**Draft Greater Geelong Planning Scheme
Amendment C431ggee
Central Geelong Framework Plan**

Advisory Committee Report

23 December 2021

Figure 14 Access to open space in Central Geelong

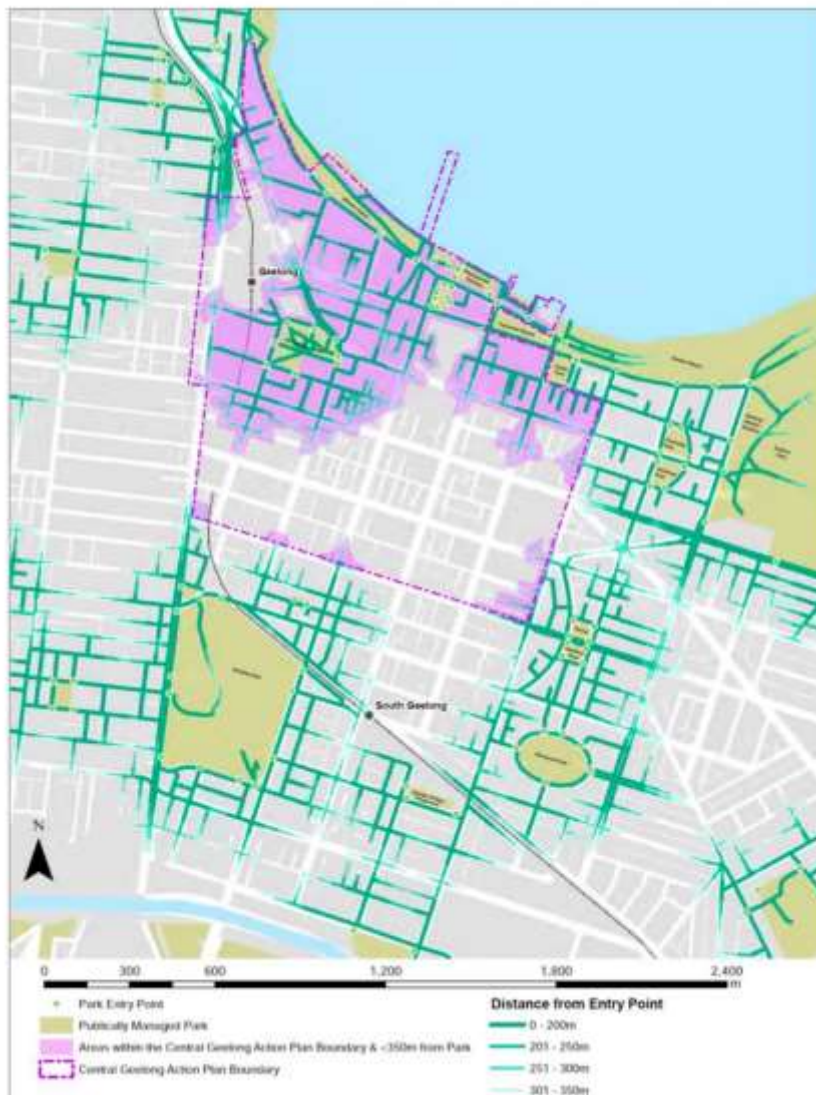
Several community submissions pointed to a lack of open space in Central Geelong, particularly in the southern parts which are some distance from the waterfront and Eastern Park. This is supported by the Open Space Network Report, which includes a map (extracted in Figure 14 below) which shows that much of the southern part of Central Geelong does not currently have convenient access to open space.

Figure 15 Mr Sheppard's modelling of allowable shadow on the Station Forecourt

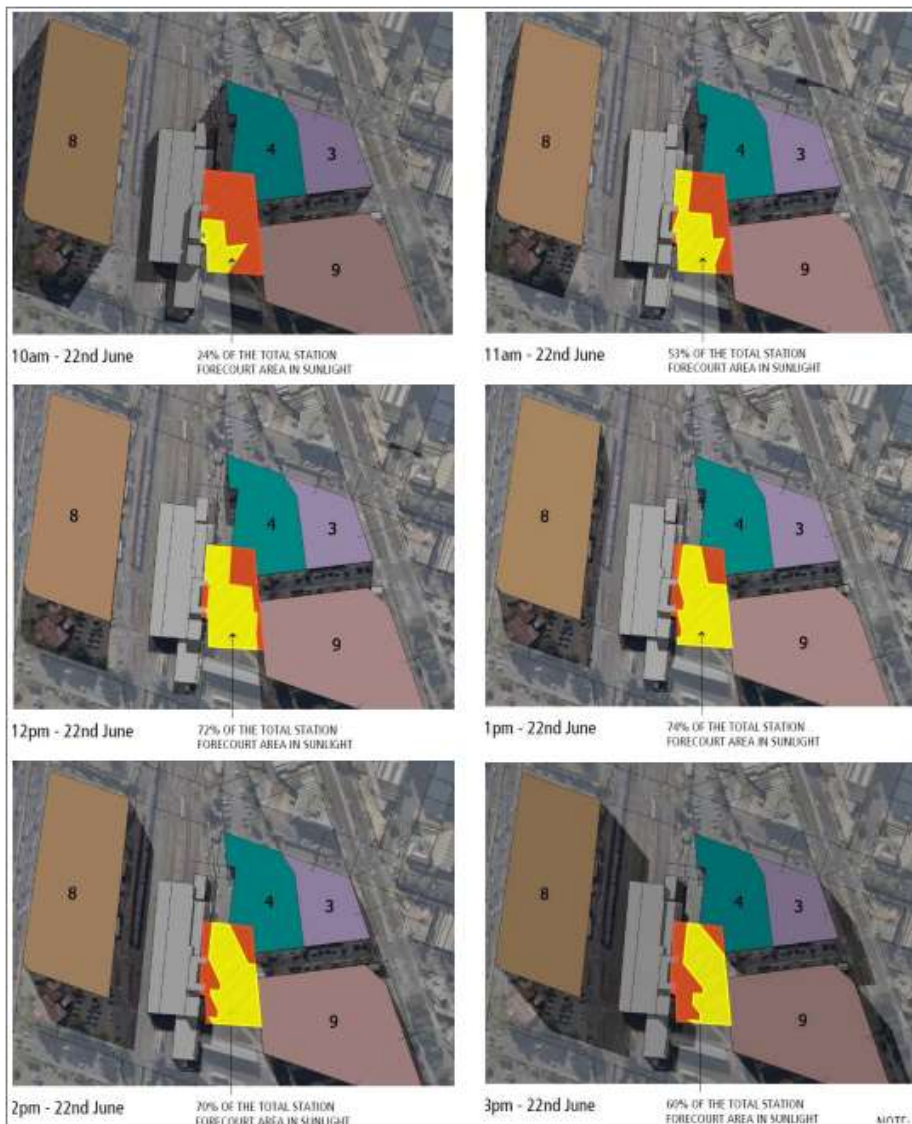
Mr Sheppard considered that from an urban design perspective, 16 metres would be an appropriate street wall height for development around the Station Forecourt. He produced modelling which demonstrated the shadow impacts of a 16 metre street wall, extracted in Figure 15. He considered that this provided for reasonable solar access to the future Forecourt, and would strike an appropriate balance between protecting solar access, producing better urban design outcomes for the Forecourt, and facilitating development in the Station Precinct.

- a) **amend Table 7 to adjust the overshadowing controls to permit allowable shadow on Johnstone Park and the future Station Forecourt based on the Day 1 street wall heights shown in Figure 13 in this report and a 16 metre street wall height around the Station Forecourt where none is specified.**

Figure 17 Modelling of intersection of preferred heights surrounding the Station Forecourt with shadow controls

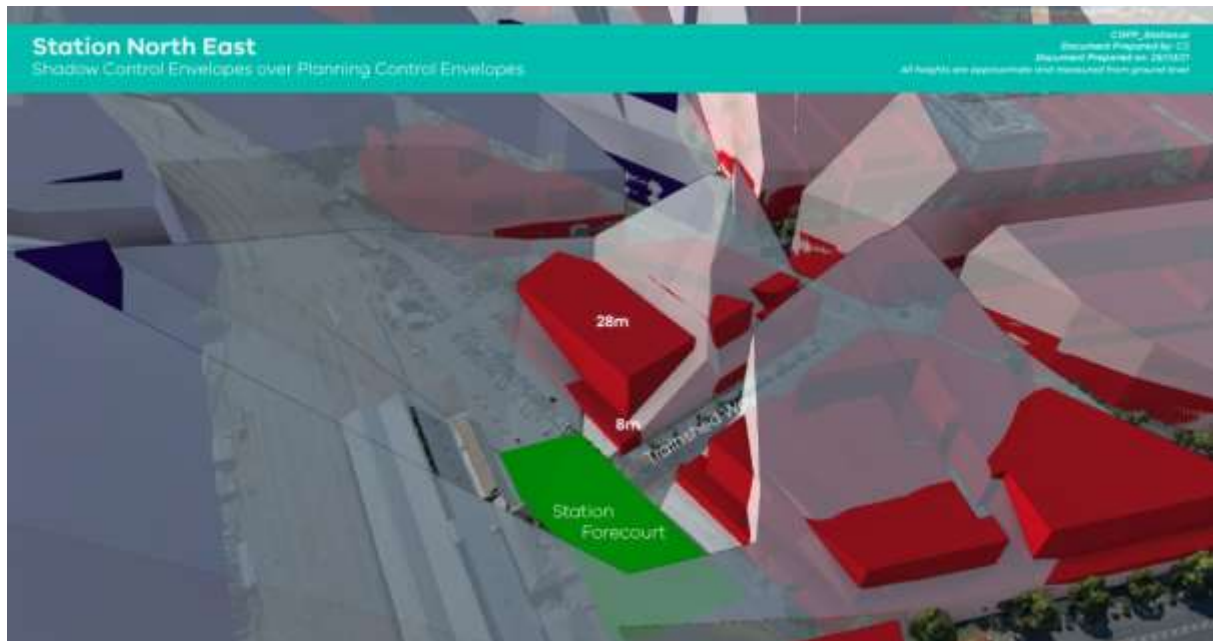
Johnstone Park and the Station Forecourt are case in point examples. Clearly, the exhibited 42 metre preferred heights in the Station Precinct to the north of Johnstone Park cannot be achieved by virtue of the shadow controls. In fact, Document 77 demonstrates that not even the revised 28 metre heights can be achieved on significant portions of those sites (refer to Figure 16 below). Further, if the shadow controls were applied as exhibited, new development around the north and east sides of the Station Forecourt would have to be significantly set back from the Forecourt edges, and/or substantially limited in height, in order to meet the controls (see Figure 17 below).

Map 6: Existing and future open space location requirements

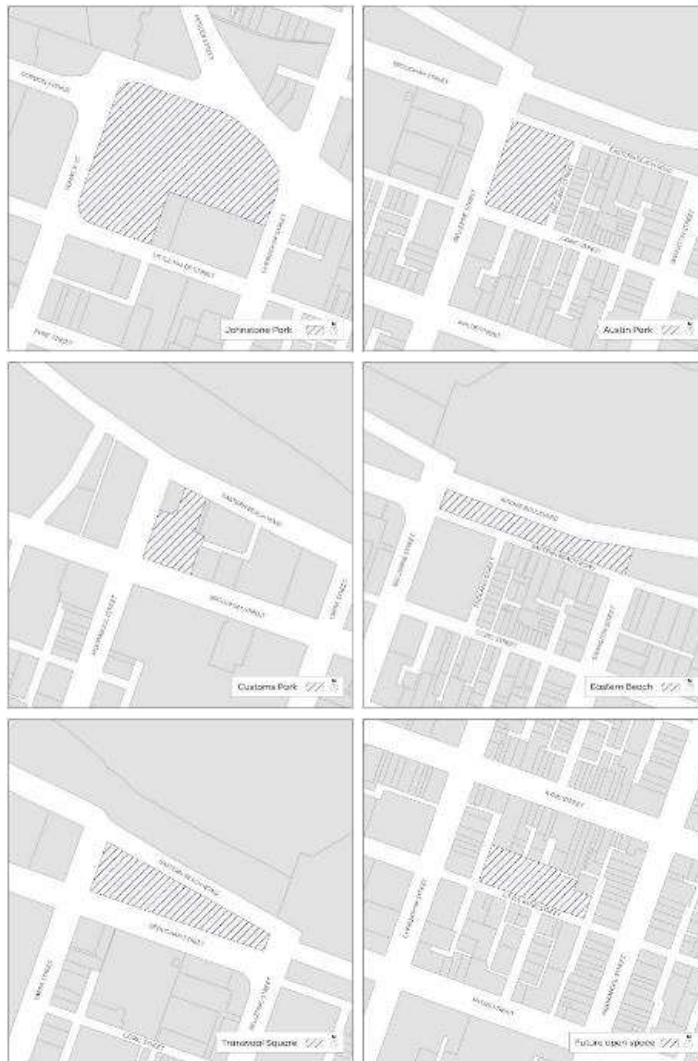
Commented [A34]: Consolidate into one map and relocate the map to immediately below Table 7

Designate the future open space at Council owned car park sites as "potential future open space subject to further investigation."
Designate the Station Forecourt as "potential future Station Forecourt subject to further investigation".
(See Consolidated Recommendation 18(a)).

Map 7: Primary and Secondary Streets

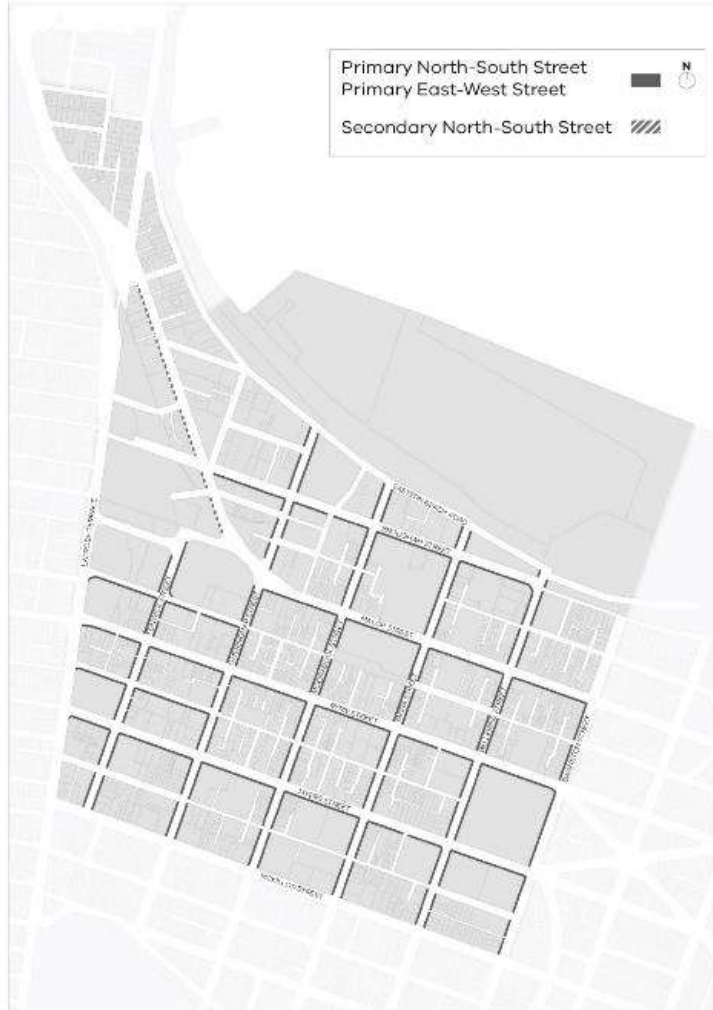
Commented [A35]: Amend the map to identify only the following as Primary Streets:

Map 13: Health Precinct Map

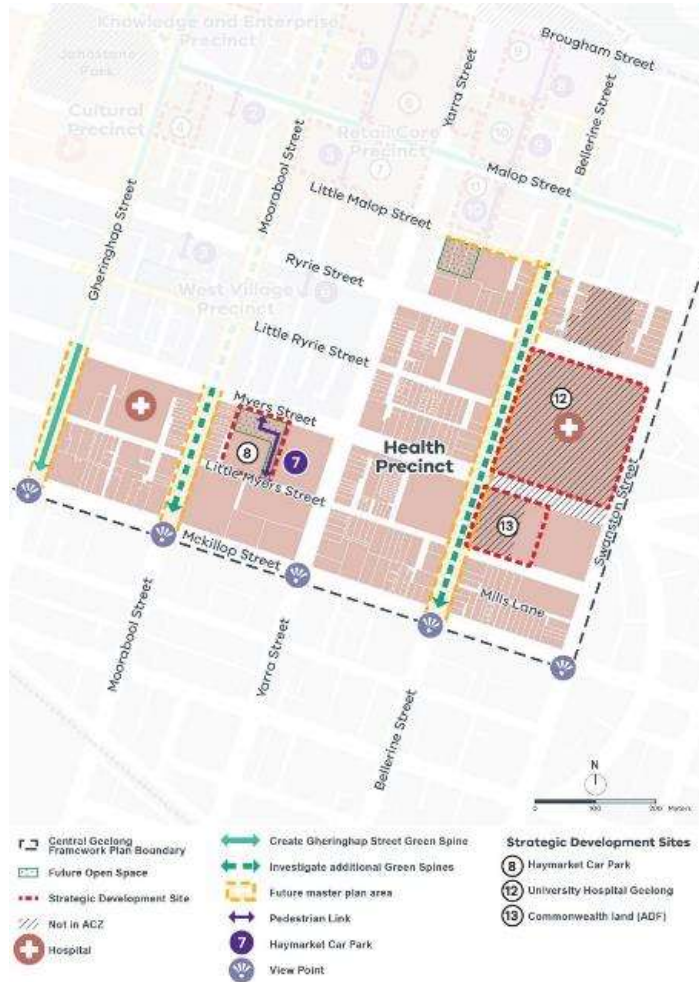
Commented [A53]: Amend the map to:

Map 15: Knowledge and Enterprise Precinct Map

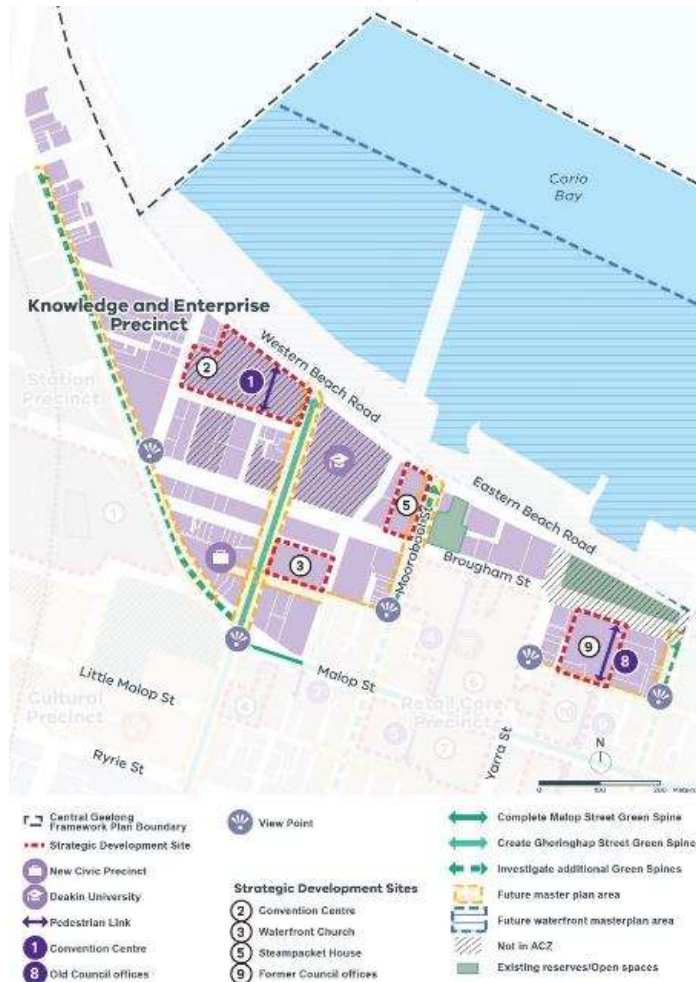
Commented [A62]: Amend the map to:
